Access Compliance Report Public Rights-of-Way (Curb Ramps)

Main Street: N/A Cross Street: 17TH_ST Location: NW

ADA ID: RPRK211008125037 Ramp Type: Type 7 - Directional 2 Initial Pass/Fail: Fail Overall Compliance: No Severity Score: 32

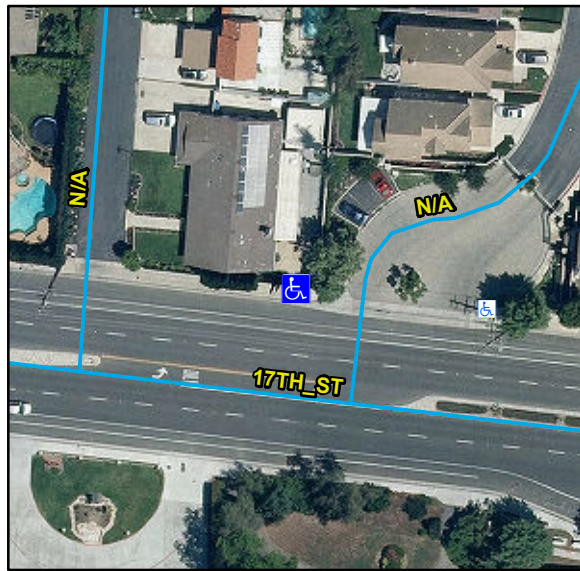
Compliance	Description	Data	Compliance	Description	Data
N/A	Ramp Length (in)	112	N/A	Flare Type LT	
Yes	Ramp Width (in)	48			N/A
No	Ramp Run Slope (%)	12.6	N/A	Flare Slope LT (%)	N/A
Yes	Ramp Cross Slope (%)	2	N/A	Flare Traversable LT	N/A
N/A	Grade Break	N/A	N/A	Flare Type RT	
N/A	Grade Break Slope (%)	N/A			N/A
N/A	Grade Break Cross Slope (%)	N/A	N/A	Flare Slope RT (%)	N/A
	Addl Para Ramp Left?	No	N/A	Flare Traversable RT	N/A
	Addl Para Ramp Right?	No	N/A	DWS Provided	N/A
N/A	Landing Present	N/A	N/A	DWS Contrast	N/A
N/A	Landing Length (in)	N/A	N/A	DWS Length (in)	N/A
N/A	Landing Width (in)	N/A	N/A	DWS Full Width	N/A
N/A	Landing Run Slope (%)	N/A		DWS Offset Type	N/A
N/A	Landing Cross Slope (%)	N/A	N/A	DWS Left Offset (in)	N/A
N/A	Landing Movement Obstructed?	N/A	N/A	DWS Right Offset (in)	N/A
	Landing Movement Type	N/A			
N/A	Landing Shared	N/A			
N/A	Marked Crosswalk 1	No	N/A	Clear Space	N/A
	Crossing 1 Direction	E	N/A	Clear Space To Crosswalk (in)	N/A

Remove & Replace Entire Ramp.
